**SUBJECT RESPONSE SUBMITTAL 2 TO THE REQUEST FOR ADDITIONAL INFORMATION
FOR TECHNICAL SPECIFICATION AMENDMENT 19 – USE OF 6% ENRICHED FUEL
License No. R-120
Docket No. 50-297**

**RESPONSE TO REQUEST FOR ADDITIONAL INFORMATION
FOR LICENSE AMENDMENT REQUEST FOR
THE USE OF SIX PERCENT ENRICHED FUEL (TAC NO. MF6088)**

**NORTH CAROLINA STATE UNIVERSITY
LICENSE NO. R-120; DOCKET NO. 50-297
DECEMBER 31, 2015**

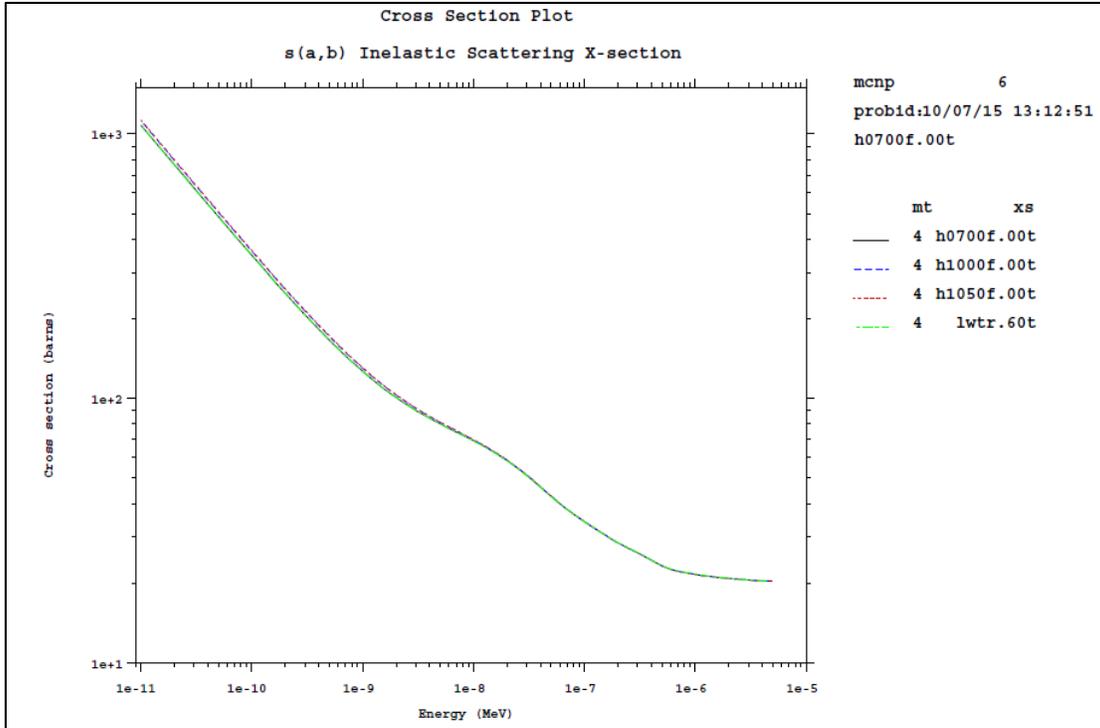
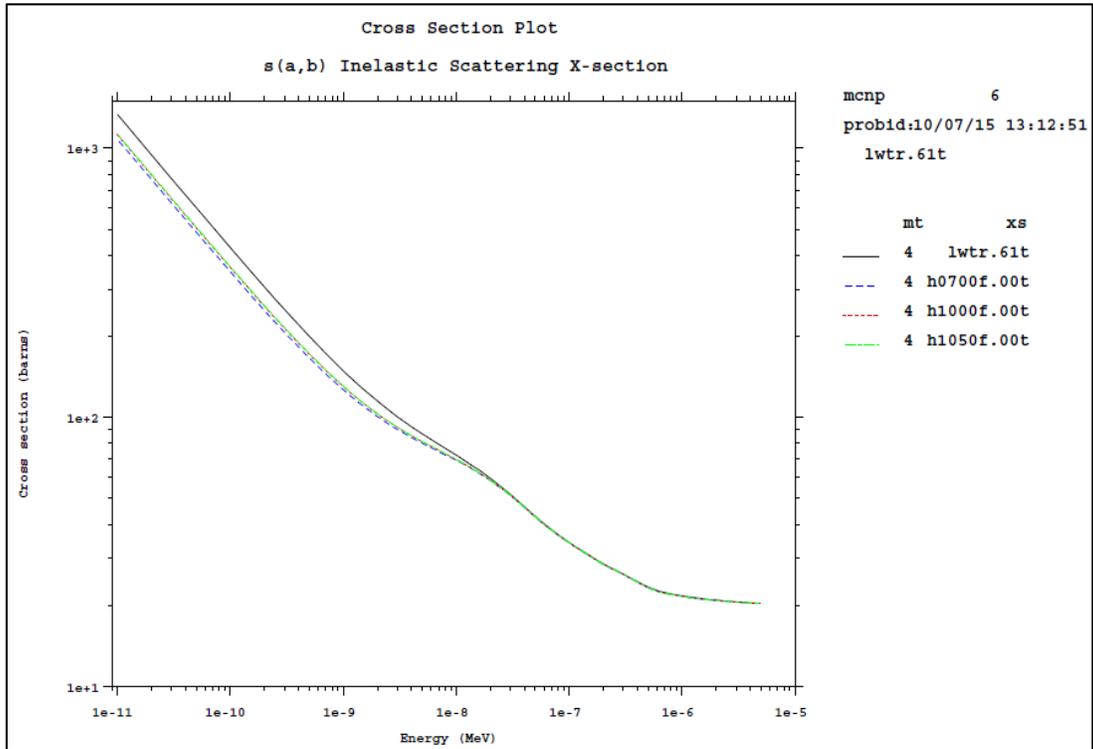
1) Explain how the MCNP6 code utilizing the ENDF/B-VII cross-sections libraries was validated and the associated uncertainty margin was addressed.

Cross section libraries generated with NJOY99 for use in MCNP6 were validated through comparison to the default MCNP6 libraries, as well as careful verification of the NJOY inputs. The comparison between default MCNP6 libraries and those generated through NJOY99 may be exemplified graphically, in which the expected behavior of processed nuclear data libraries (e.g. due Doppler broadening) are observed.

Total cross-sections corresponding to H in H₂O S(α,β) library generated using NJOY are compared to the MCNP6 libraries at 68.8 °F (lwtr.60t) and 260 °F (lwtr.61t) in Figures 1 and 2 respectively. The temperature at which each library was processed is listed in Table 7. The default MCNP6 libraries are lwtr.60t and lwtr.61t, which were originally processed with NJOY99. Libraries for H in H₂O demonstrate an increasing total cross-section with increasing temperature, approaching a 1/v behavior at low energies. As expected all cross-sections are between the 68.8 °F and 260 °F MCNP6 libraries, with the 70 °F (h0700f.00t) approximately equal to the lwtr.60t library.

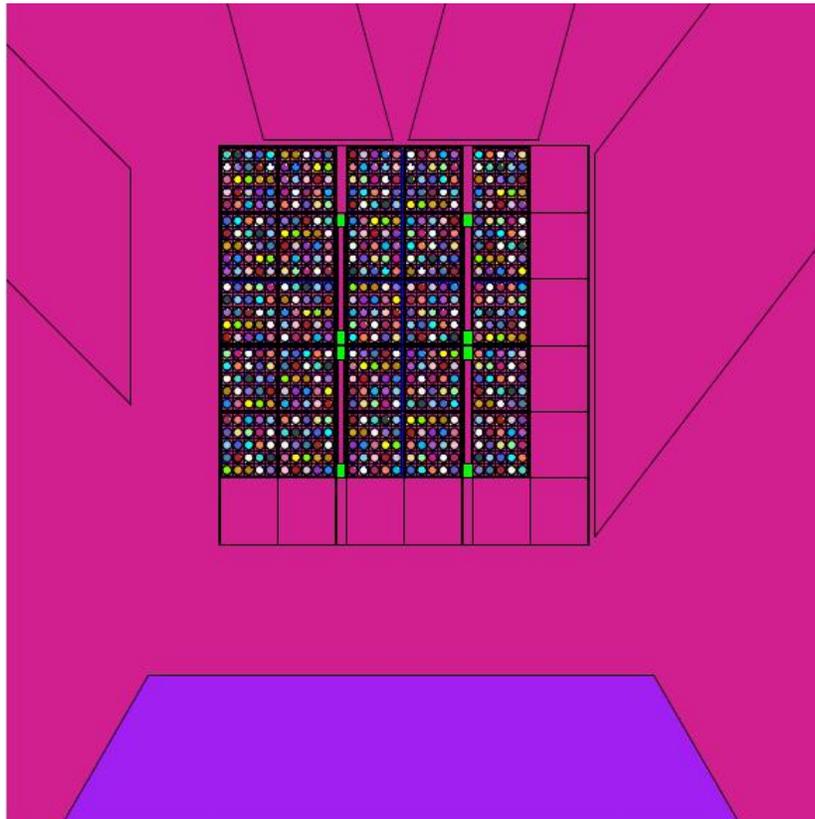
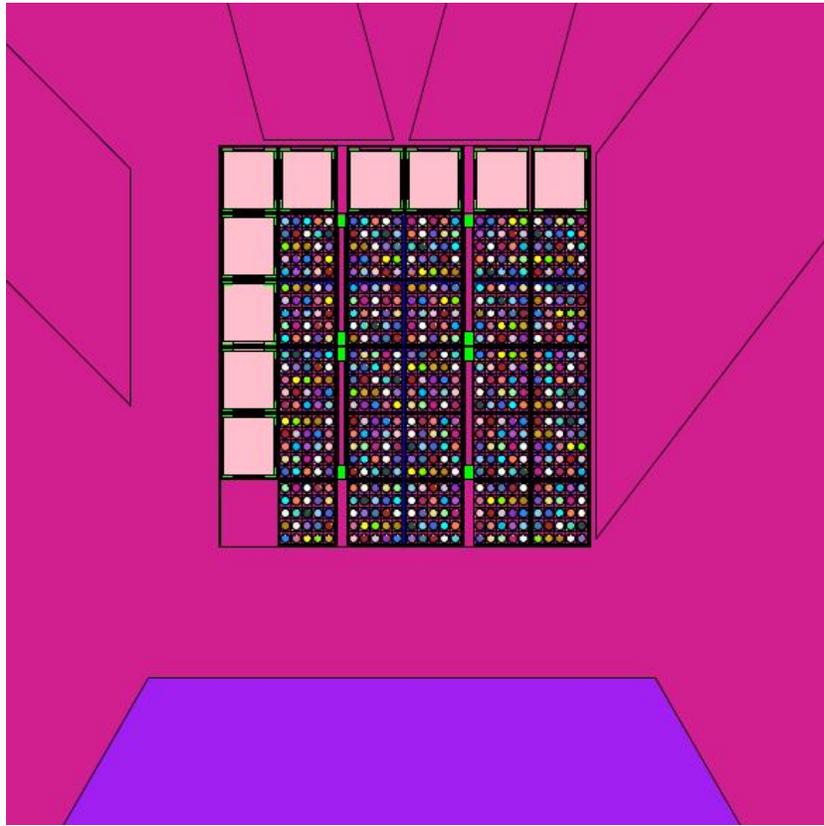
- j) Discuss the verifications of model geometry definition and input data as well as configuration changes for specific core analyses (i.e., fuel shuffling locations) that were performed.**

Geometry was verified through the use of the MCNP6 MCPLLOT module to visualize the geometry and ensure the lack of errors. In addition, the use of common geometry for all models, and the establishment of cell and material identification conventions for new materials, minimized the opportunity for geometrical errors. In the creation of new models, geometry changes were visualized and verified for consistency within the input files.

Verification through the use of MCNPLOT is demonstrated for the standard core and reflected core 8 in Figures 7 and 8, respectively. In each case, the cross-sectional ‘slice’ of the core is at the core mid-plane. Geometry cells are colored according to material. Consequently each unique fuel volume is distinguishable.

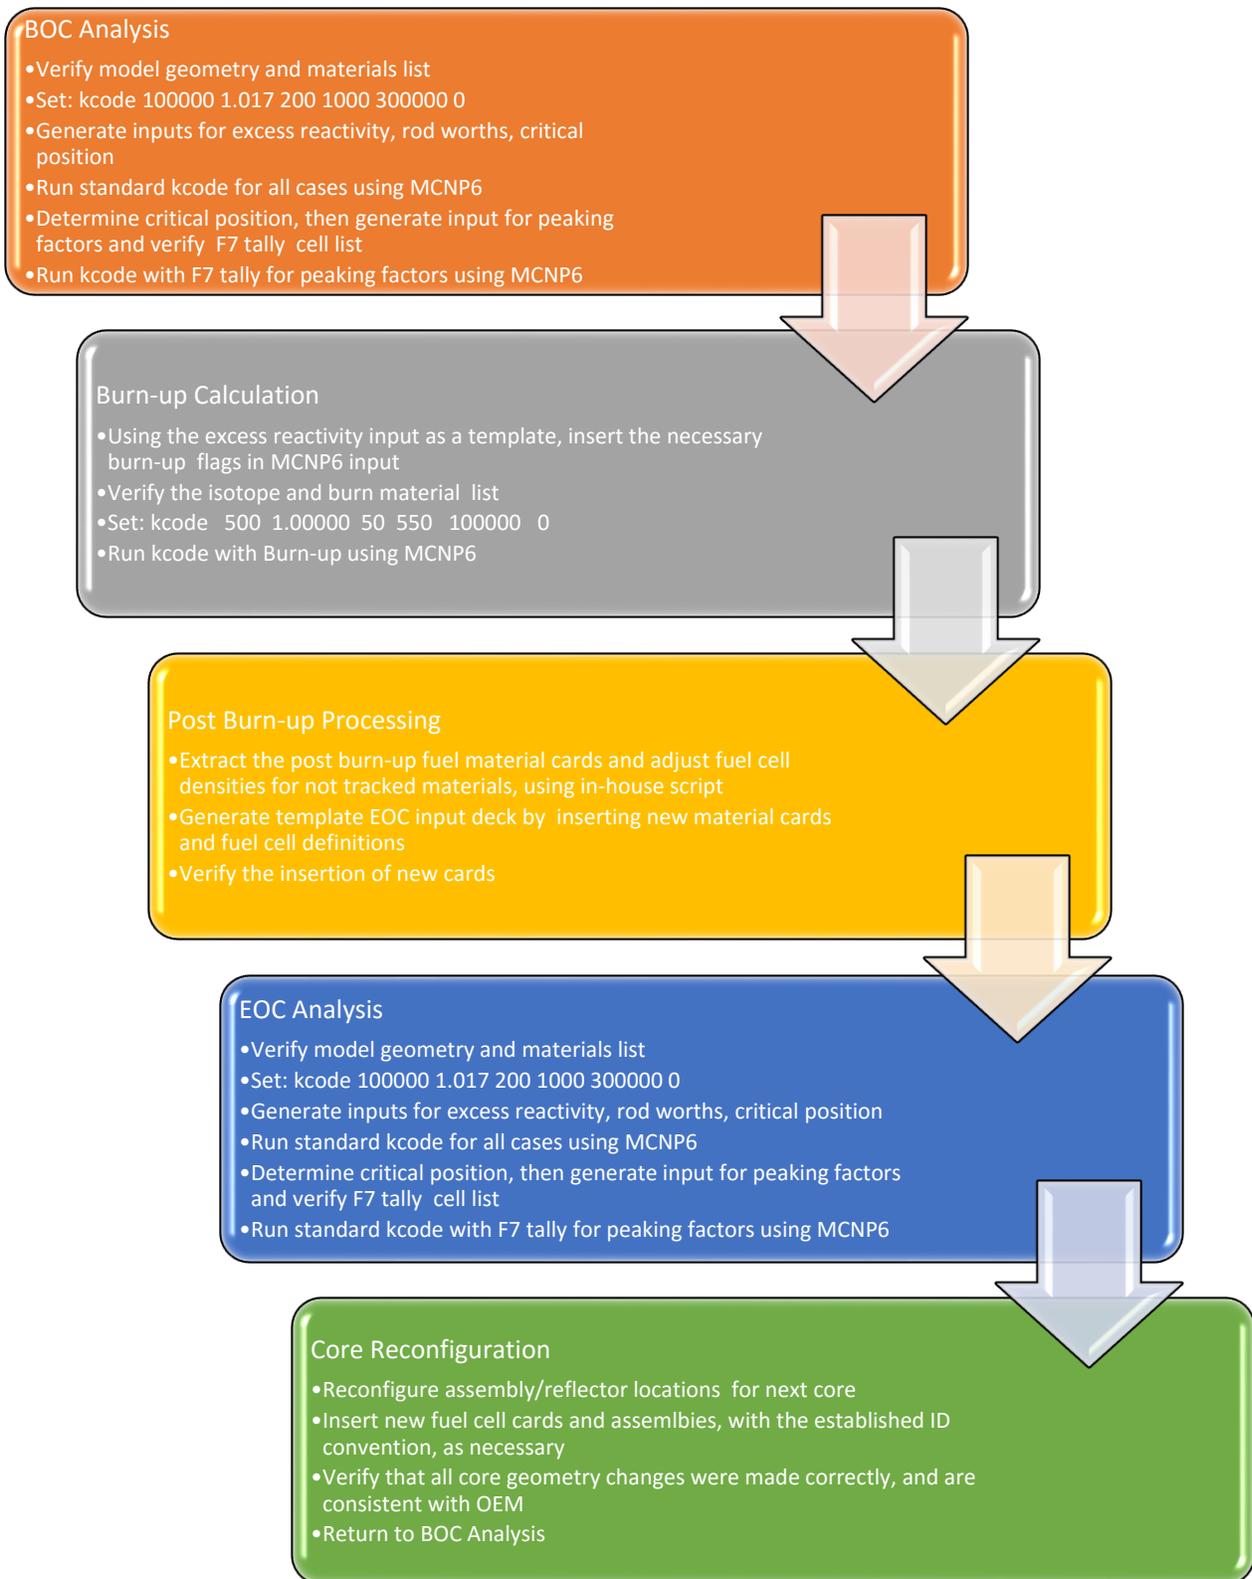
k) Discuss the extent computer scripts were used to shuffle fuel assembly locations vs. manual data entry.

Computer scripts and codes were used extensively for fuel shuffling. The heavy use of universes in MCNP6 permitted the fuel to be moved with minimal changes to the input file. The material and cell identification convention were exploited in scripts to redefine material cards and fuel volume cell densities (to account for isotopes that were not tracked) between core configurations. Following the use of scripts to perform fuel shuffling, the data entries were verified by visual inspection. Shown below is a flow chart of the analysis process that was used for each core configuration.
